1 REDLINE REVISION: January 30, 2006

Revision "A"

MARYLAND DOT - STATE HIGHWAY ADMINISTRATION
Office of Traffic & Safety
TRAFFIC ENGINEERING DESIGN DIVISION
(Traffic Signal Plan)
US 40 at Coudon Blvd (Formerly Ikea Connector Road)

DRAWN BY:	M. Howell	F.A.P. NO.	N/A	TS NO. 4173-A	SHEET NO.
CHECKED BY:	T. Zaydel	S.H.A. NO.	BW996M82		
SCALE:	1" = 20'	COUNTY:	Cecil	T.I.M.S. NO. H-046	1 OF 2
DATE:	Date	LOG MILE:	0700400.40

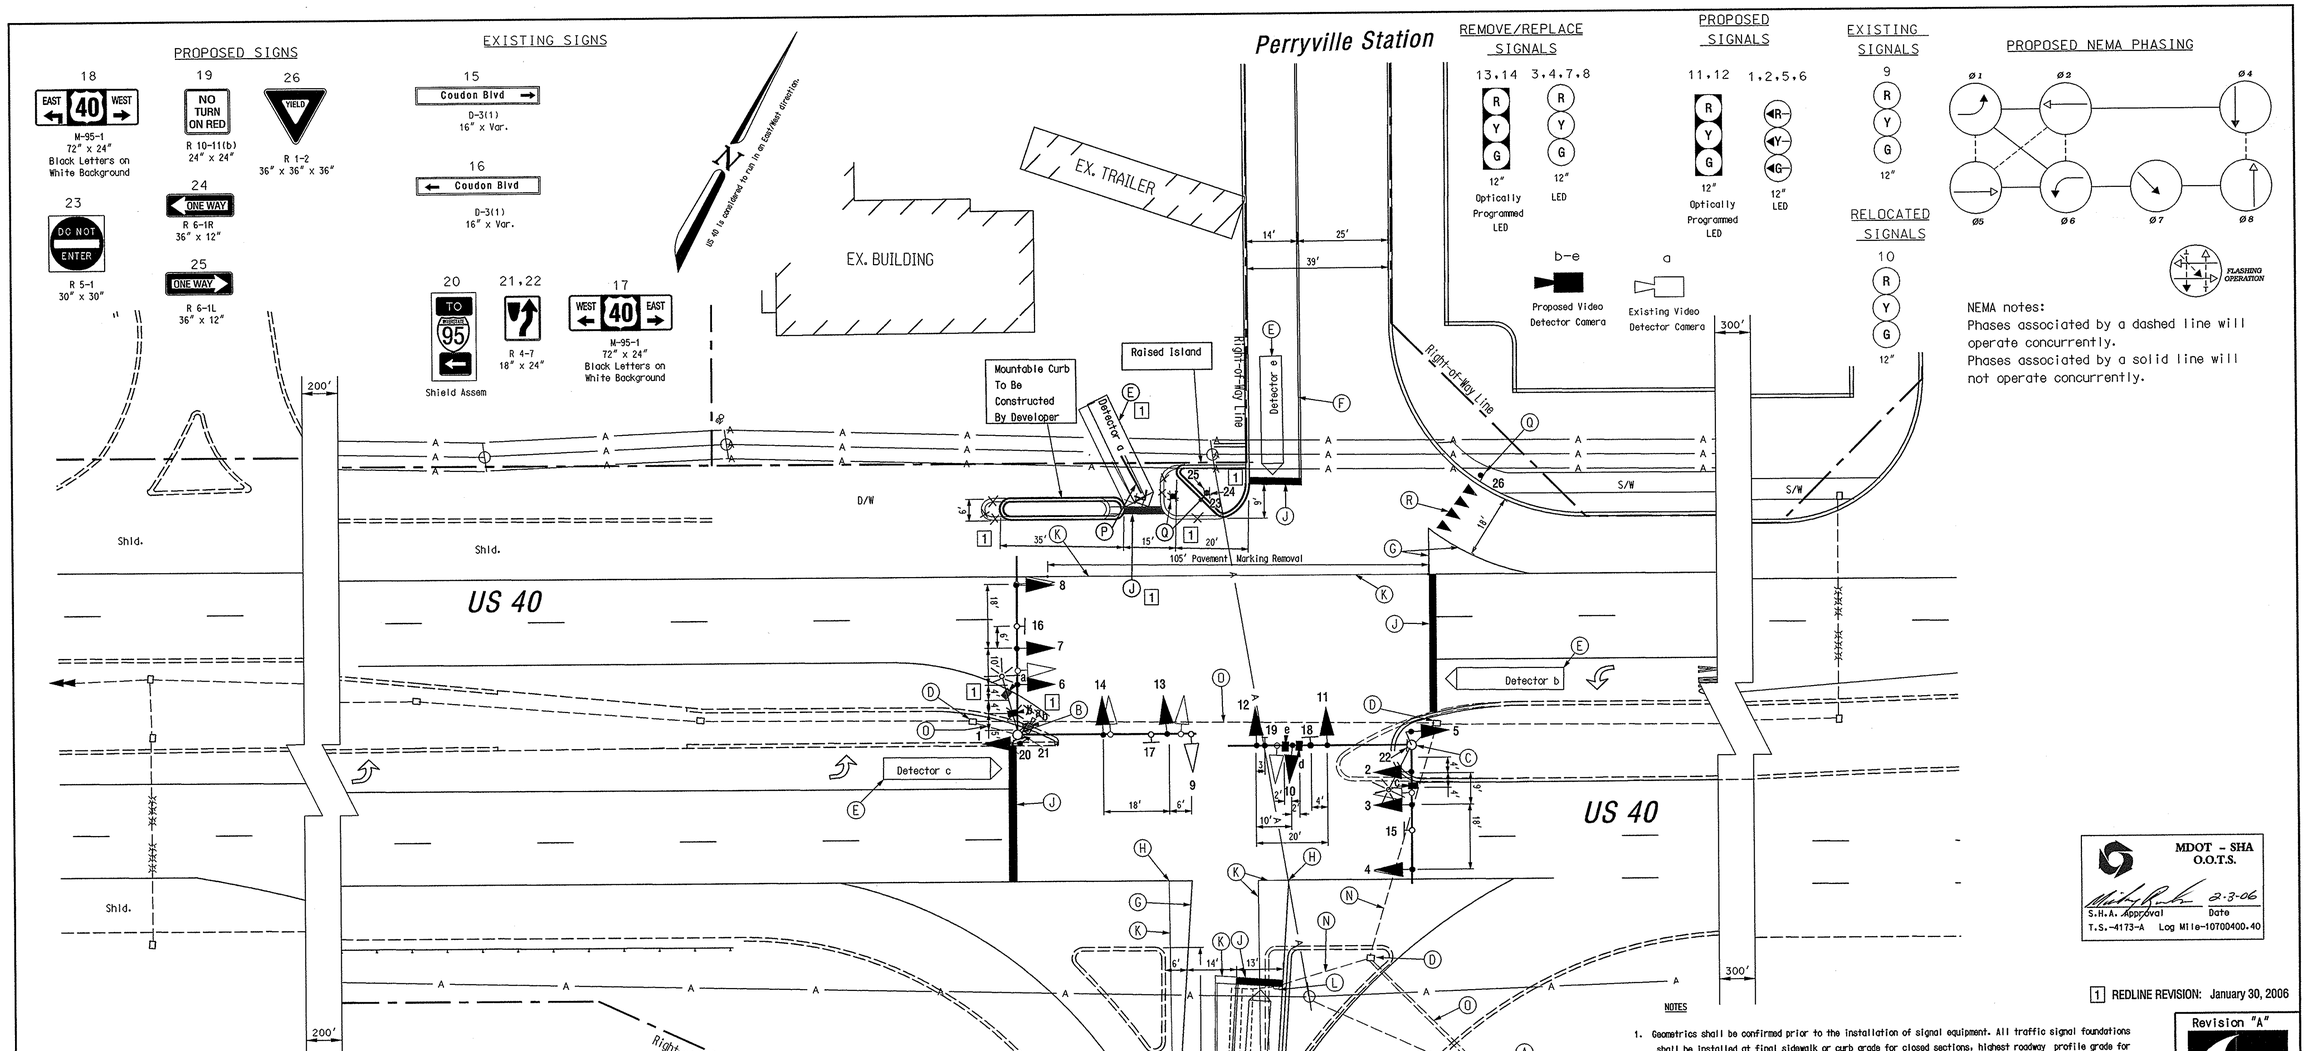
A. Use existing base mounted cabinet/controller, and all attached equipment
B. Use existing mast arm pole and mast arms. Install/Replace vehicle signal heads. as shown. Install video camera detection [Camera (a)] near end of lighting arm and adjust existing video detection [camera (b)] to new camera zone location for Eastbound US 40 turn lane.. (1)

C. Use existing mast pole and remove existing mast arm. Install new 50 ft arm with vehicle signal heads, signs, and video camera detection. sign. Rake existing mast arm pole as necessary.

L. Remove existing handhole.
M. Abandon existing loop detector.
N. Cap and abandon existing conduit.
O. Use existing conduit.
P. (1) Install pavement marking symbol (Wrong Way Arrow) as shown. Symbol length may be modified as necessary.

Q. (1) Install ground minted sign as shown.
R. Install YIELD Pavement marking symbol as shown. (6 total) See Detail.

REVISIONS					
A	Geometric modifications, add video camera detection. S.H.A. No. 10995M82	Nov. 2, 2005			
FJH
